SERVICE DIRECTIVE BULLETIN NO. T-057

1.    SUBJECT:    Fuel Quantity Transmitter - Cover and Gasket

2.    MODEL:        480 and 480B

Figure 1: Inactive Gasket and Cover (flat edge)  
(Parts removed for clarity; Actual gasket color is medium blue)

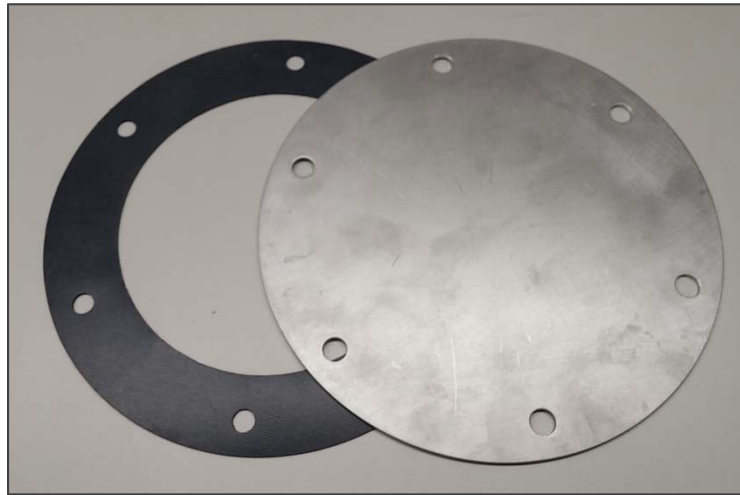
Enstrom has received a report of a failed fuel quantity transmitter attributed to water leakage as a result of insufficient sealing around the perimeter of the fuel quantity transmitter cover.

- 6.3 Inspect the fuel quantity transmitter wiring for condition and security.
- 6.3.1 Clean the electrical contacts to remove any residue.
- 6.3.2 Remove any corrosion from the fuel transmitter case ground location.
- 6.3.3 Apply a corrosion inhibitor (see paragraph 8) to the case ground wire and the transmitter wire connections.
- 6.4 Proceed with step 7.
7. UPGRADE INSTALLATION:
- 7.1 Inspect the fuel quantity transmitter cover for a flat (Figure 1) or flanged (Figure 2) edge.

- 7.2 If the cover has a flanged edge, no further action is required.
- 7.2.1 If the cover was removed, reinstall existing gasket or install gasket P/N 4122065-35.
- 7.2.1.1 If the previous gasket was cork, replace with a new P/N 4122065-35.
- 7.2.2 Reinstall the cover, if required.
- 7.2.2.1 Ensure the cover is wiped clean and dry prior to installation.
- 7.3 If the cover has a flat edge, replace the cover with flanged edge cover, P/N 4122065-33.
- 7.3.1 Remove the cover, if not previously removed.
- 7.3.2 Perform step 6.2 and step 6.3, if not immediately performed previously.
- 7.3.3 Remove existing gasket and install gasket P/N 4122065-35.
- 7.3.4 Install cover P/N 4122065-33.
- 7.4 Verify fuel quantity transmitter operation.
